**SITE AND ARCHITECTURAL REVIEW COMMITTEE**
City of Campbell, California

# MEMORANDUM

| **Subject:** | Site and Architectural Review Permit | | |
| **File No.:** | PLN-2020-61 ~ 1351 Peggy Ave | | |

Exterior Elevation Front

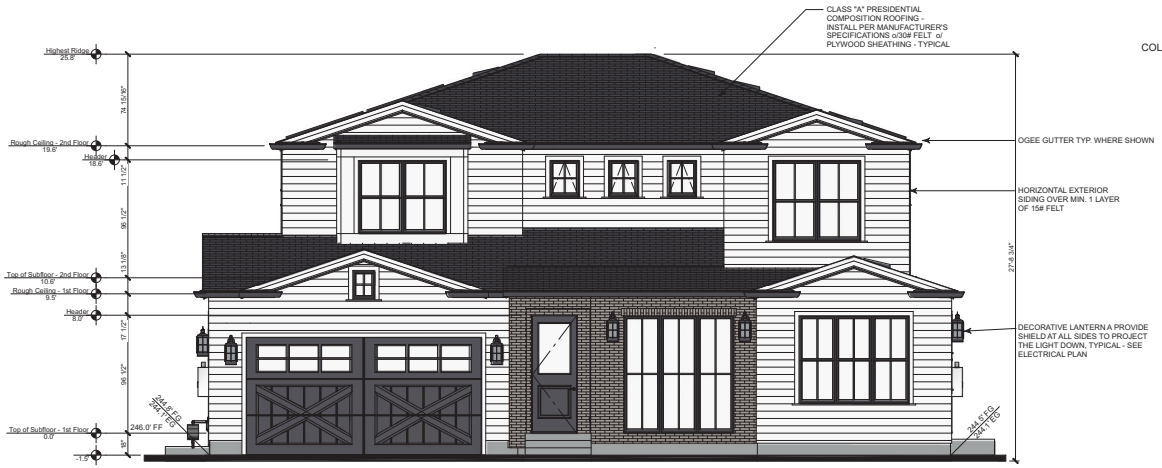
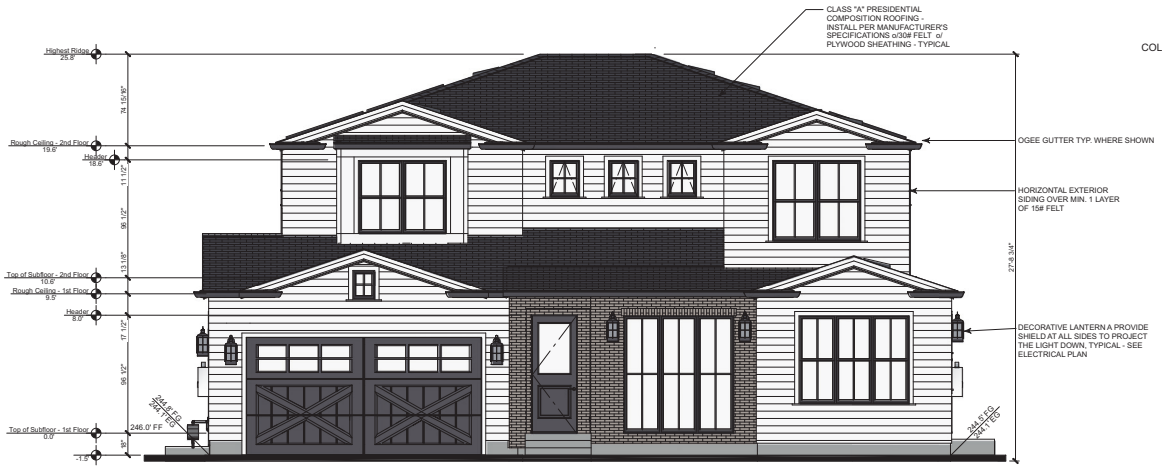
Surface Articulation: The STANP calls for new homes to "avoid long unarticulated wall and roof planes especially on two-story elevations." In response to comments the applicant incorporated changes in the wall materials by incorporating stucco and horizontal siding. The SARC should consider if the proposed wall treatment changes are adequate to address wall and roof plane articulation issues.
